Application by RiverOak Strategic Partners Limited for an Order granting Development Consent for the reopening and development of Manston Airport in Kent

REQUEST FOR COMMENTS AND FURTHER INFORMATION

Response by No Night Flights to the Department for Transport letter dated 17th January 2020 – NNF25

RSP Map 12.6 – Aircraft Noise Day-time LAeq 16hr contours, year of forecast maximum capacity

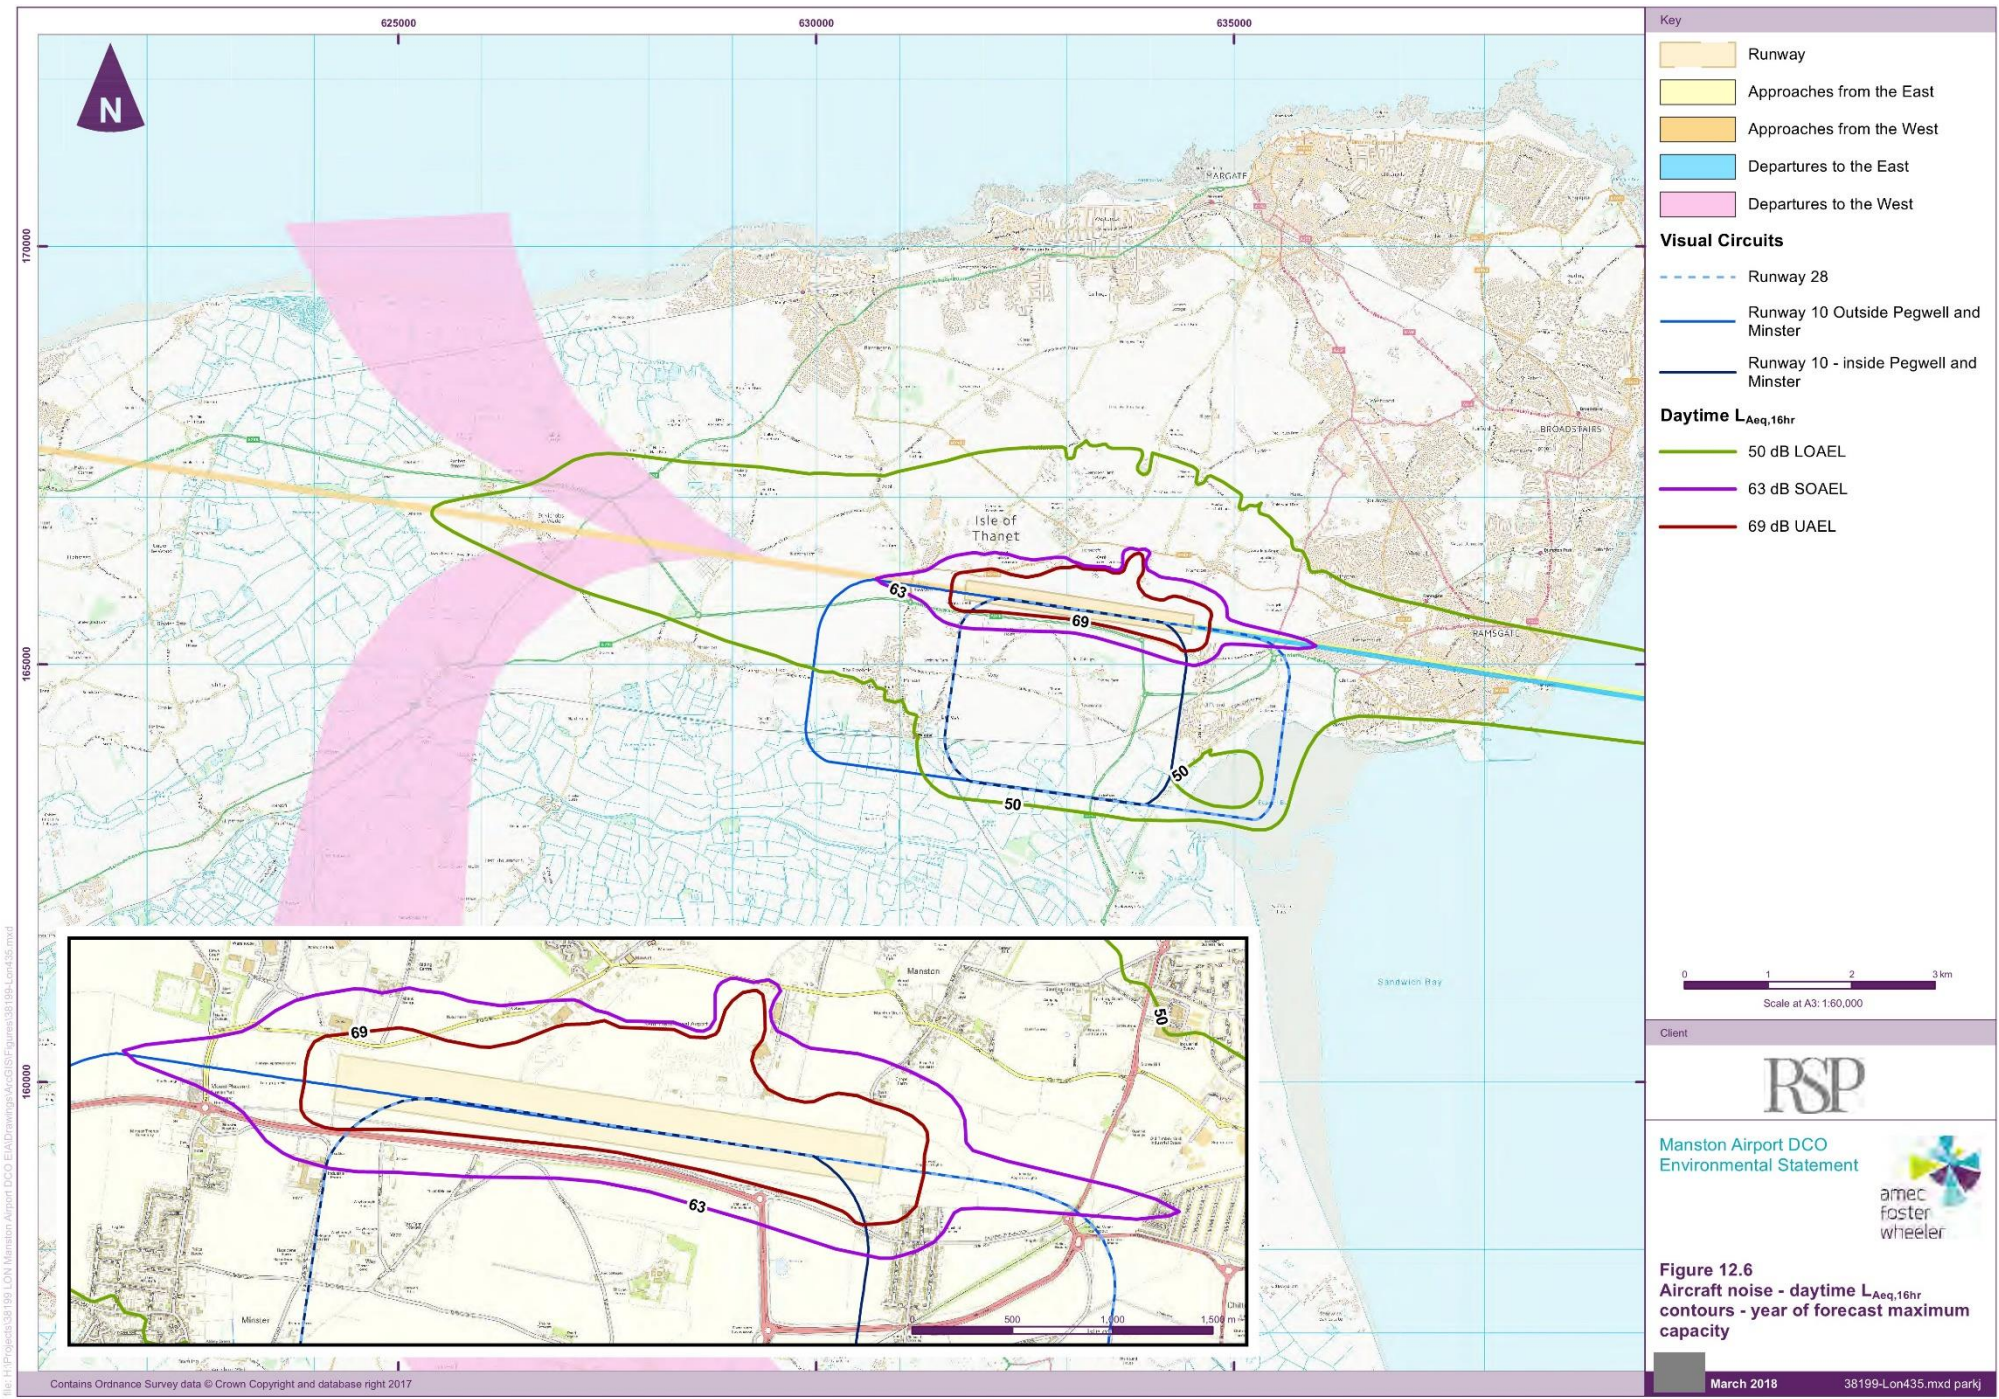
73. The best comparator that we can find for our Map 6 is RSP’s Figure 12.6 (see page 66) – daytime LAeq 16 hour, Year 20. Of course, RSP has averaged operations to the east with operations to the west. This means that the noise impact is considerably understated in RSP’s

85. Again, the contours in Map 8 are larger than the contours in RSP's Figure 12.6 from its ES (see page 66). In Ramsgate, RSP's 50dB LAeq contour falls partly inside the CAA's 51dB LAeq contour and then runs with the CAA's 54dB LAeq contour to the north.

RSP Map 12.7 – Aircraft Noise Night-time LAeq 8hr contours, year of forecast maximum capacity

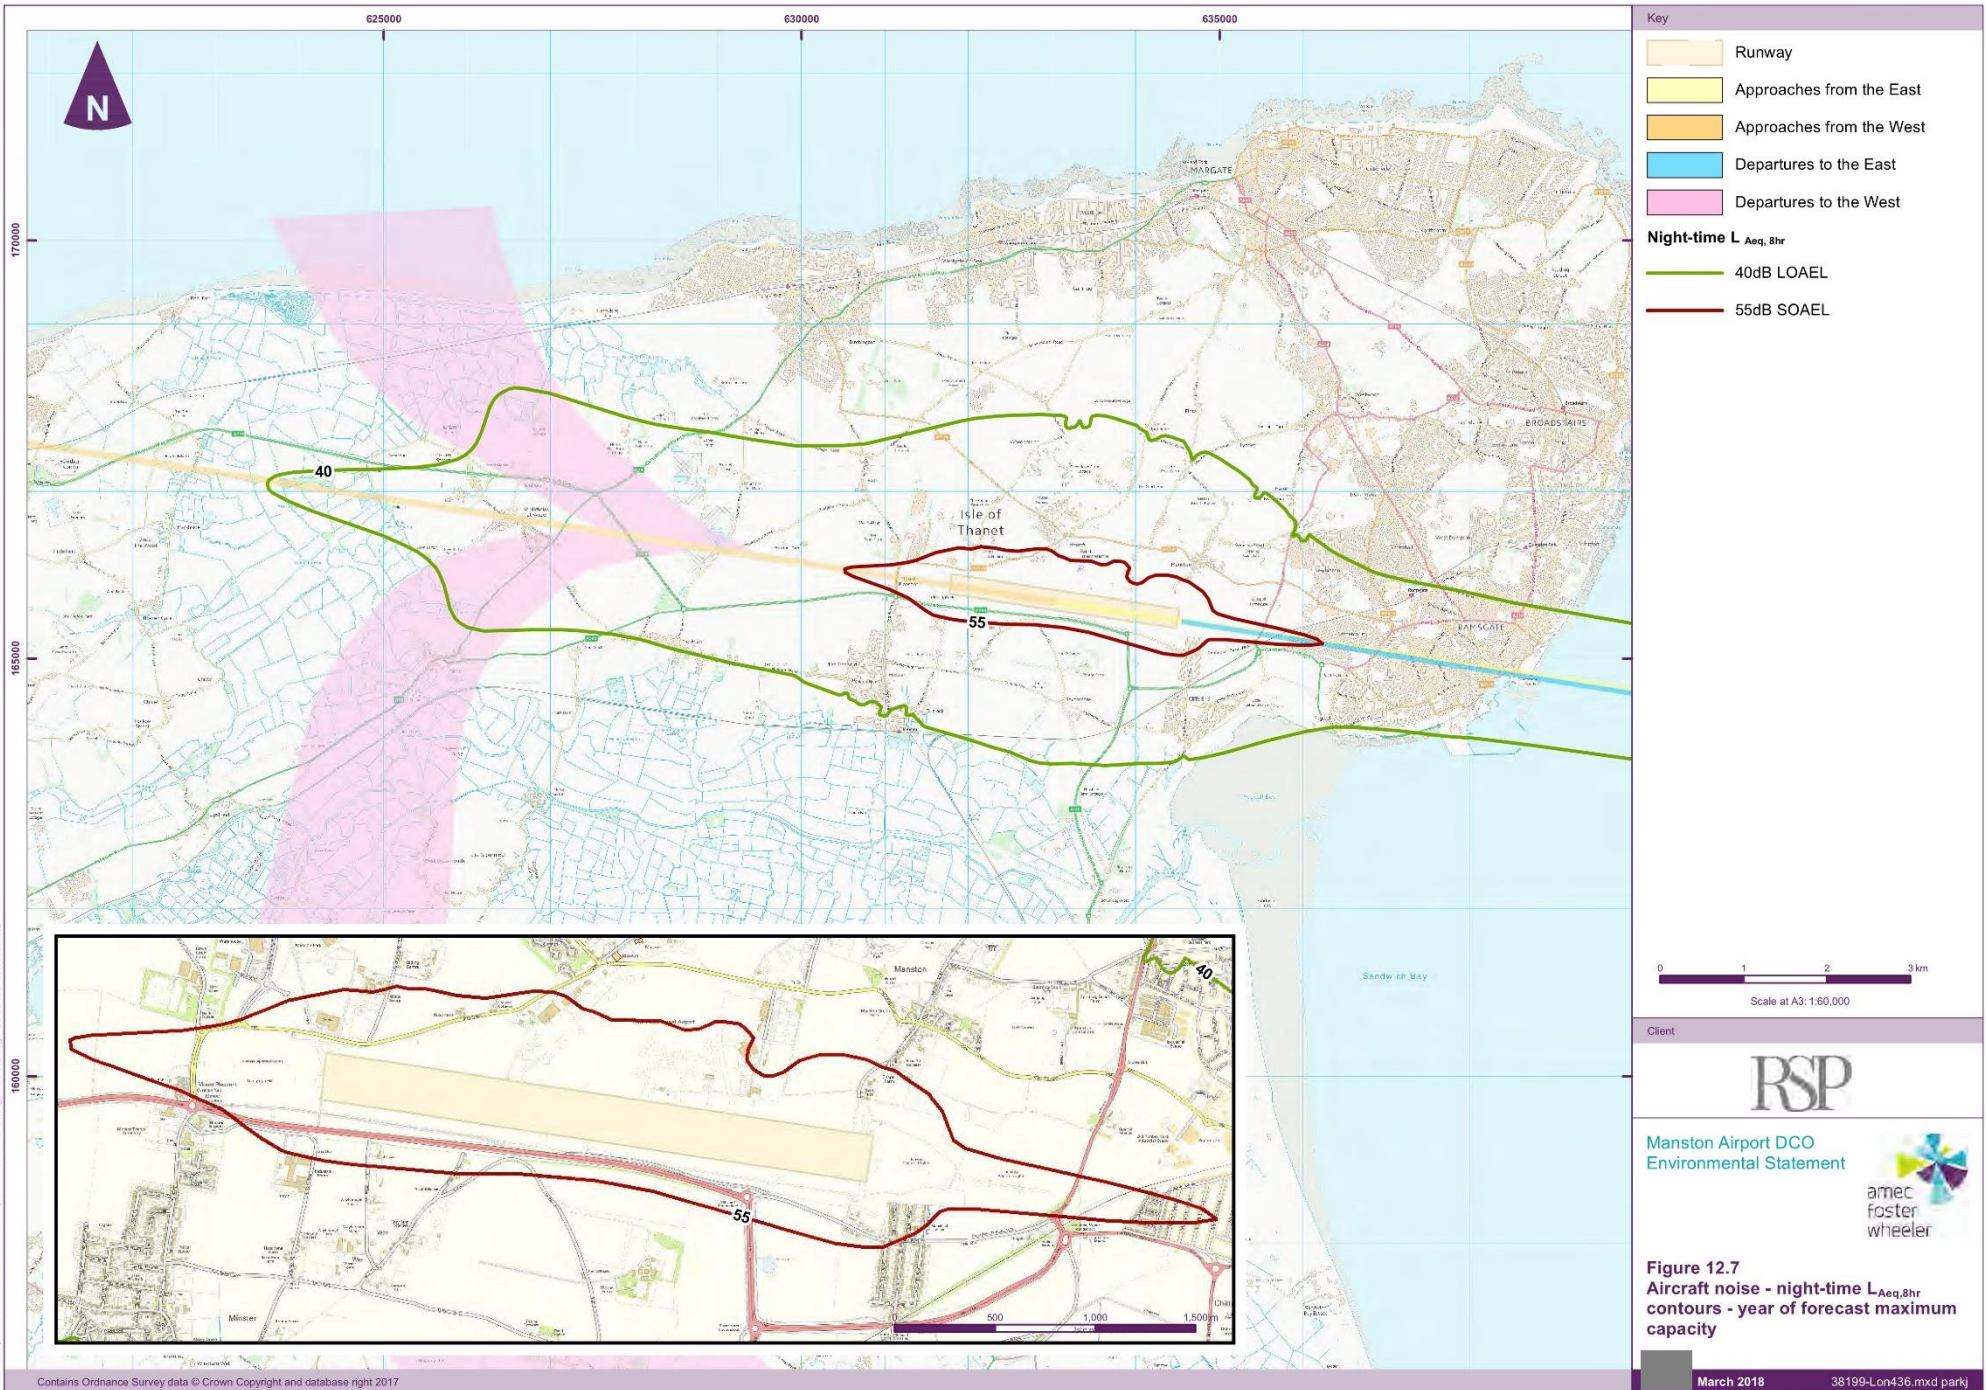
100. RSP's night LAeq contours are in the ES at Figure 12.7 (see page 67). It is hard to know how RSP calculated these contours given the confusion amongst the RSP team when asked at the ISH on Environmental Issues in June what underpinned its night operation assumptions and what fleet mix and number of ATMs led to RSP's desire for a 3,028 annual QC budget. It can be seen from RSP's Figure 12.7 that RSP has significantly understated the potential noise impact of the night flights that it could operate whilst staying within its desired QC budget and whilst following its statements about welcoming late arriving cargo planes at night and allowing passenger planes to take off from 0600.

101. RSP has shown only the 40dB and the 55dB night contours. Looking at Map 10 above, RSP's 40dB contour is smaller than the CAA's 45dB contour in the west and is closer to the CAA's 48dB contour. Looking at Map 11 above, RSP's 40dB contour is similar to the CAA's 45dB contour in the east. RSP's Figure 12.7 disguises the fact that the 57dB Night contour stretches well into Ramsgate and that much of the town would experience average night noise of 51dB.

RSP Map 12.9 – Aircraft Noise Night-time LASmax contours, year of forecast maximum capacity

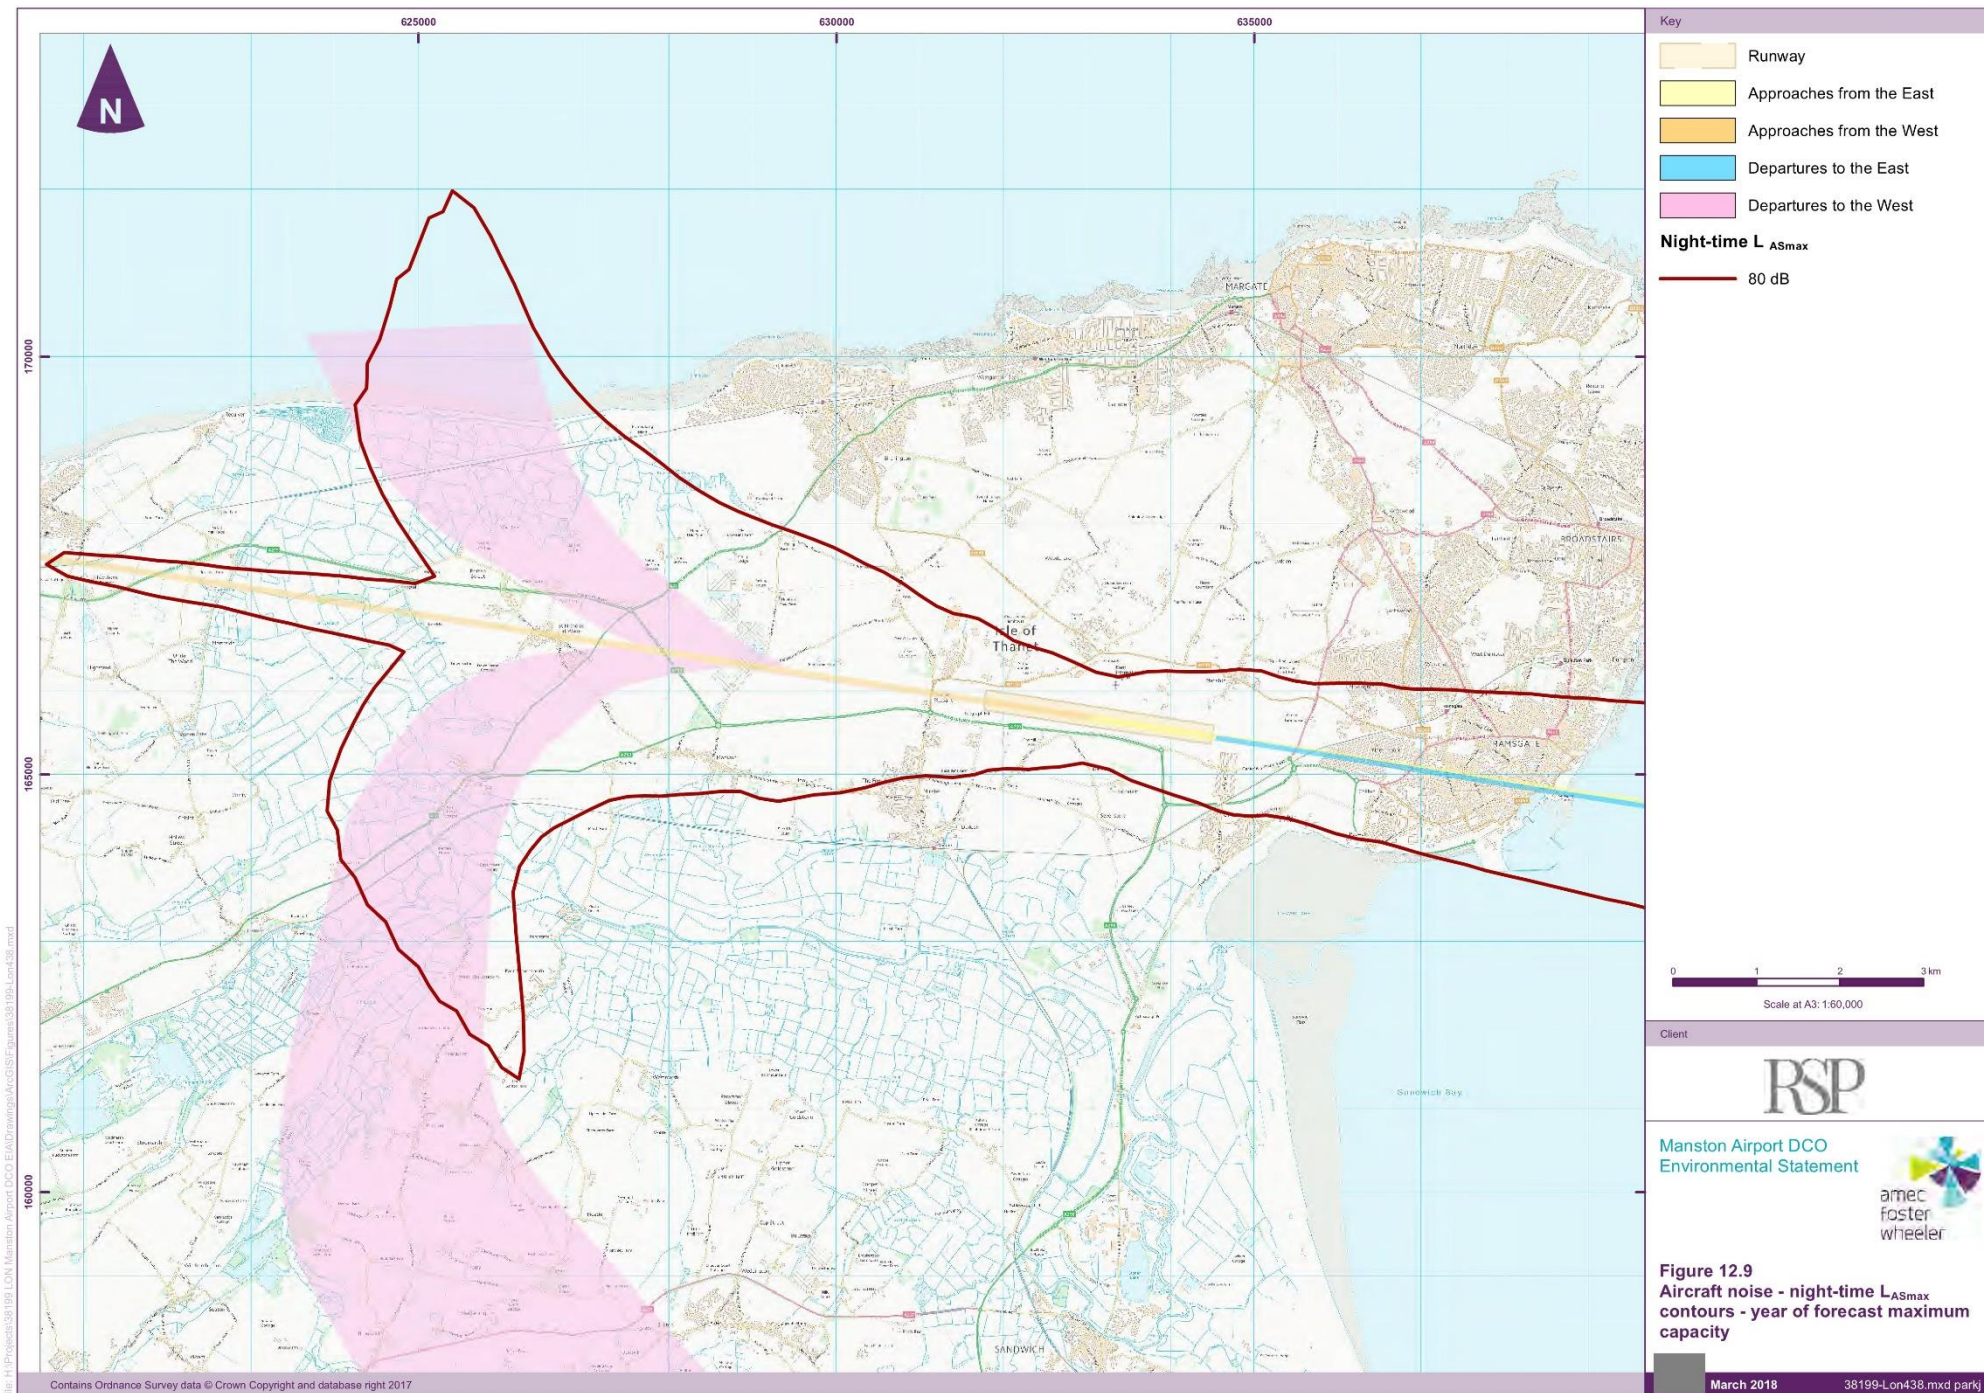
64. A comparison of RSP’s Figure 12.9 (page 68) with NNF’s Maps 1 and 2 reveals a significant noise impact that RSP has simply not shown. The 70dB contours extend over the entire town of Herne Bay in the NNF contours. RSP has only modelled 80dB LASmax and so Herne Bay does not even appear on its maps. This suggests that Herne Bay will be entirely unaffected by aircraft noise – an assertion often made by the RSP team at various consultation events. However, Herne Bay residents know from experience that a single 747-400 creates a significant noise footprint. A 747-400 overflying Herne Bay in the daytime is loud enough to make people look up as it goes over. At night, the impact is greater. The real impact on Herne Bay residents is entirely missing from RSP’s assessment of noise impact.
